DOCUMENT CHANGE REQUEST

DCR number 362	Changes required for: N/A	Originator: Jean-Laurent BOUTEAUX
Date: 2007/06/19	Date sent: 2007/06/19	Organisation: CNES
Status: IMPLEMENTED

Title:	Contacts Electrical Triax Crimp for 3401/056 Connectors		
Number:	3401/066	Issue:	2

DRAFT MARK-UP
FOR DCR 362

~~VARIANT 01~~ STRAIGHT SLEEVE (Code 1)

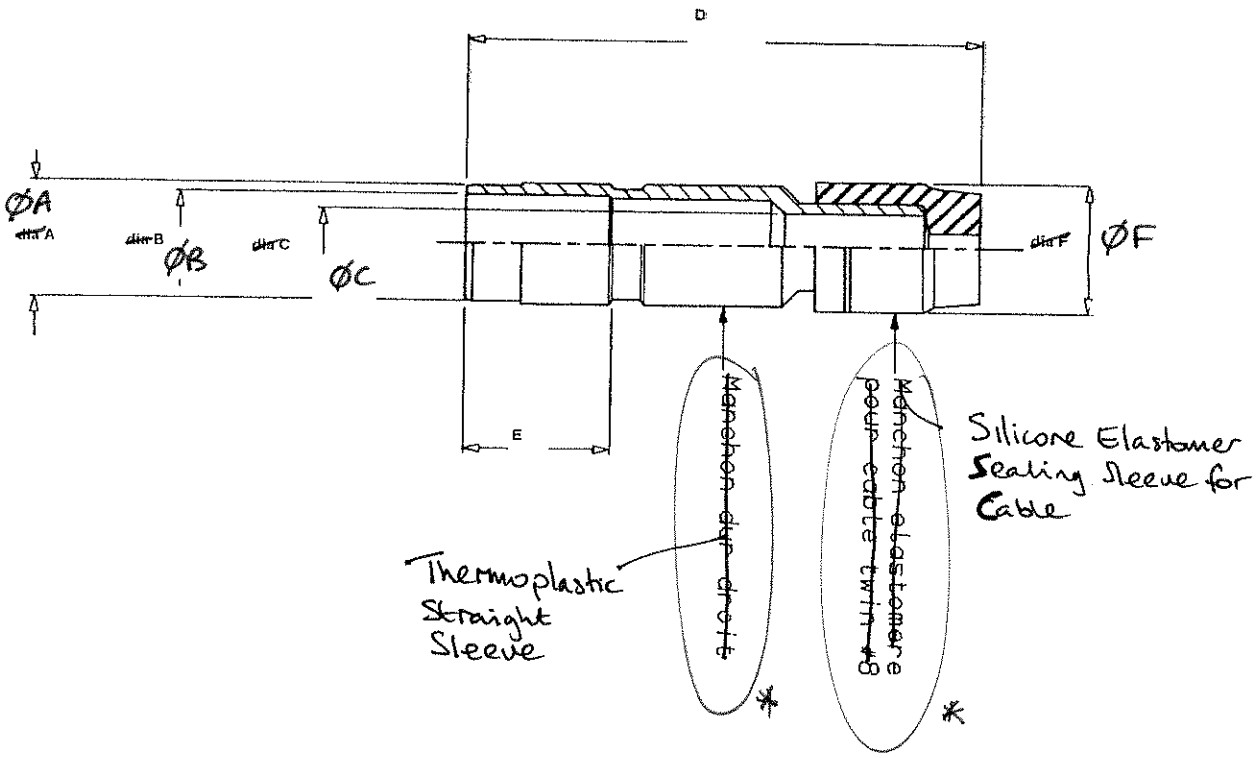
Implementation of the new sealing sleeve options shall be as detailed in the attached mark-up.
Paras & Pages affected:
Table 1(a), Figure 2, Para 4.3.2, new Para 4.4.3, Para 4.5.2, new Para 4.5.2.1
A new sealing sleeve code is defined as a suffix to the ESCC component number to facilitate specification of both male & female contacts (variant 01 & 02 respectively) with a straight sleeve (code 1), with an elbow sleeve (code 2) and without any sleeve (code 0). The contact/sleeve configurations available are defined in Table 1(a) notes 1 & 2.

* ENGLISH DRAWING REQUIRED

SYMBOL	MILLIMETRES		REMARKS
	MIN.	MAX.	
Ø A	8.30	8.40	
Ø B	7.05	7.15	
Ø C	4.80	4.90	
D	35.40	36.50	
E	10.30	10.50	
Ø F	9.2	9.5

FIGURE 2 - PHYSICAL DIMENSIONS
FIGURE 2(b) - SEALING SLEEVES
~~VARIANT 04~~ ELBOW SLEEVE (Code 2)

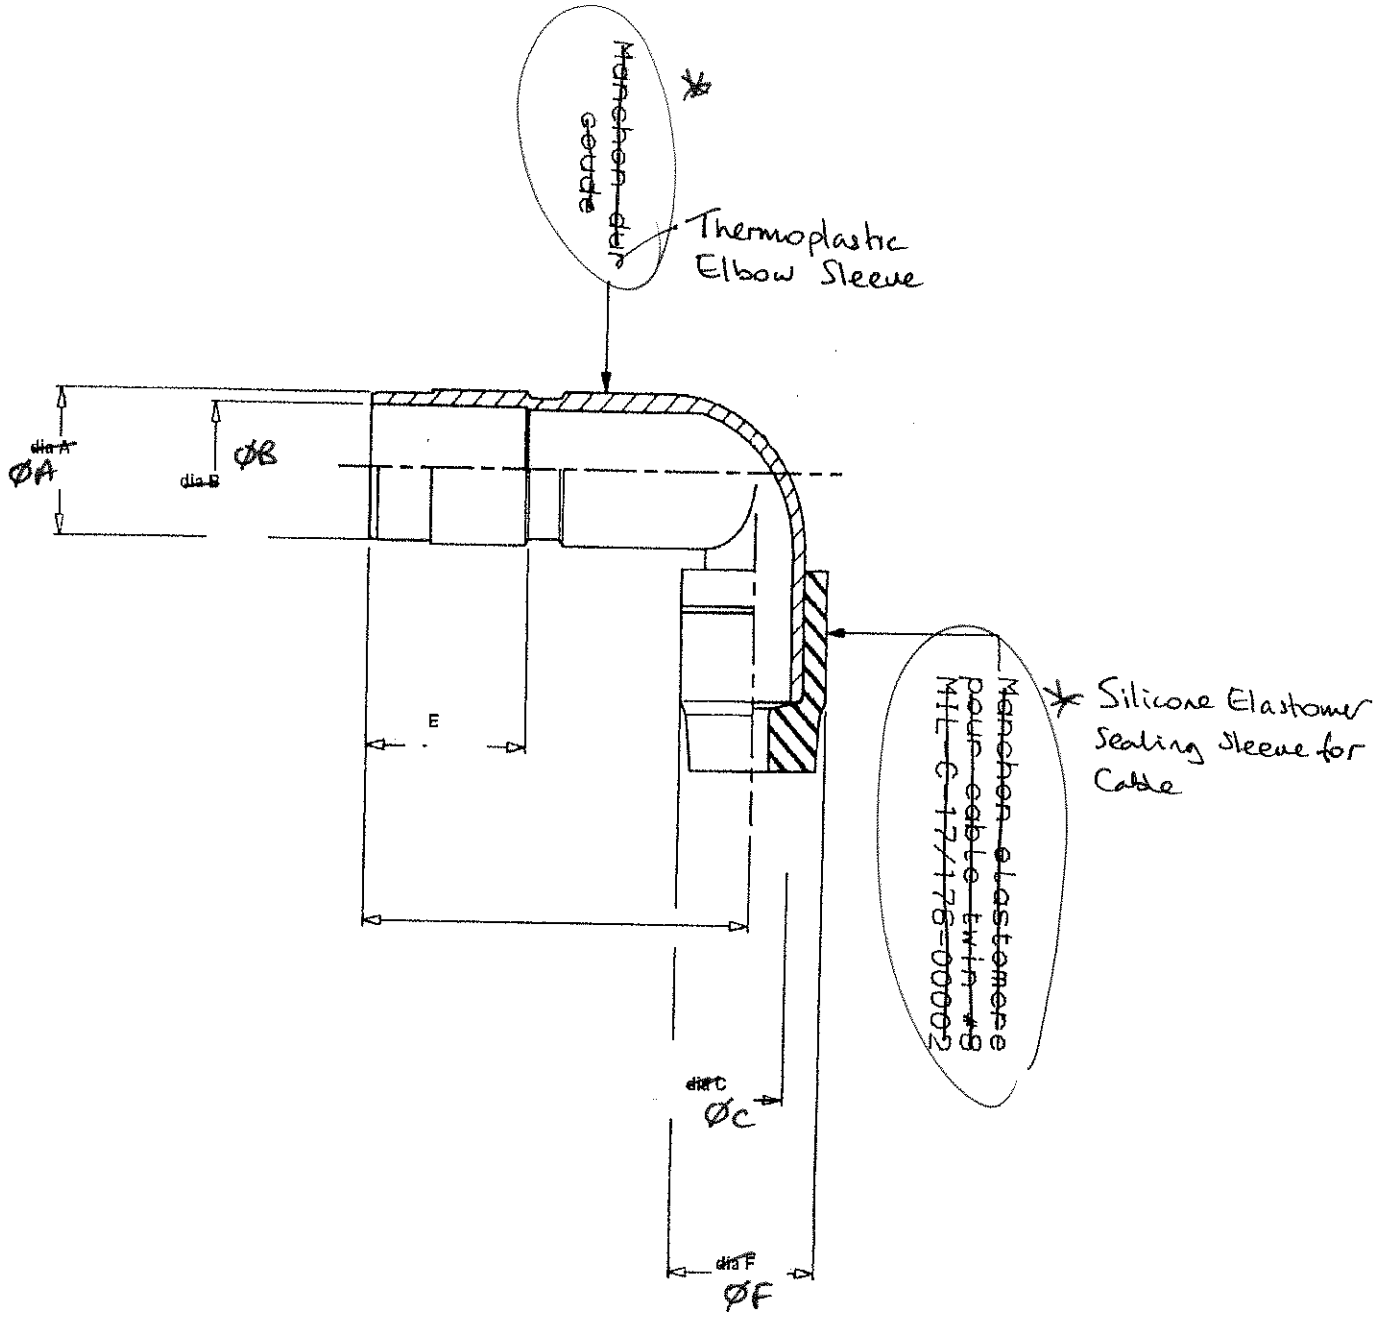
* ENGLISH DRAWING REQUIRED

SYMBOL	MILLIMETRES		REMARKS
	MIN.	MAX.	
Ø A	8.30	8.40	
Ø B	7.05	7.15	
Ø C	4.80	4.90	
D	25.00	25.20	
E	10.30	10.50	
Ø F	9.20	9.50

VARIANT 03 , STRAIGHT SLEEVE

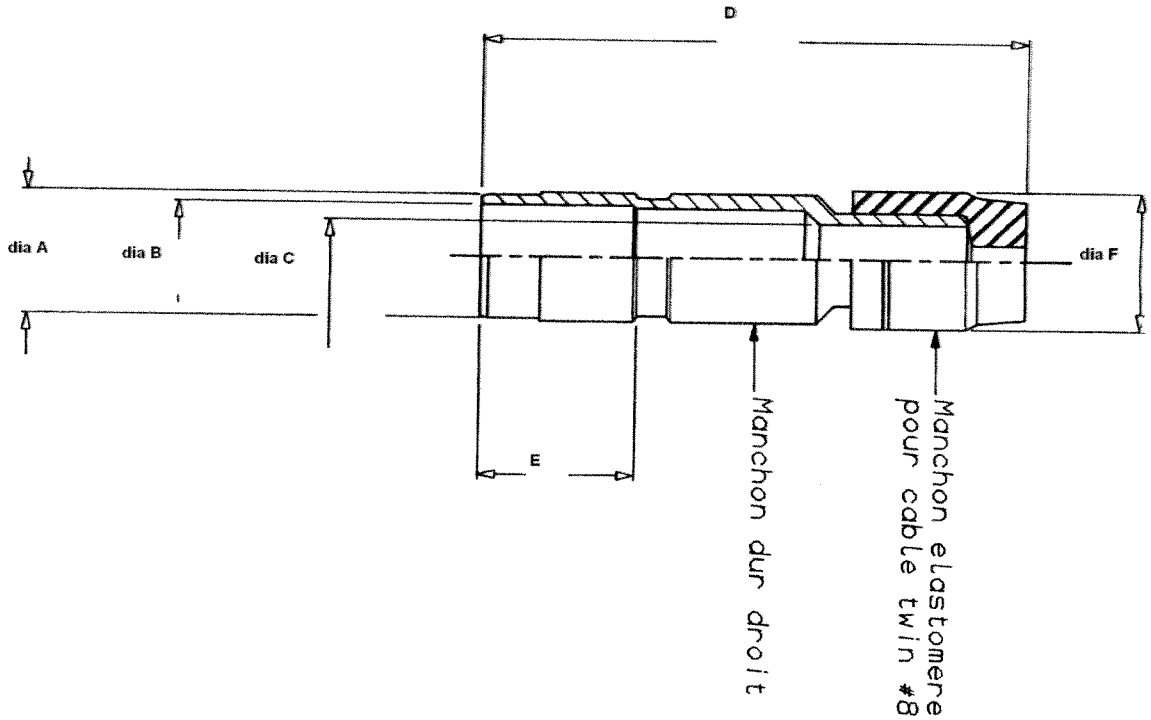
page 6, in table 1(a) , add variant 03 and 04
Add : - page 8-1 Variant 03 , straight sleeve
- page 8-2 Variant 04 . elbow sleeve

The use of triaxial contacts 3401/066 01B and 02B , requires the assembly of the sealing sleeves 3401/066-03B (straight) or 3401/066-04B (elbow) to preserve all the connectors performance (except for layout 09-01)

SYMBOL	MILLIMETRES		REMARKS
	MIN.	MAX.	
Ø A	8.30	8.40	
Ø B	7.05	7.15	
Ø C	4.80	4.90	
D	35.40	36.50	
E	10.30	10.50	
Ø F	9.2	9.5
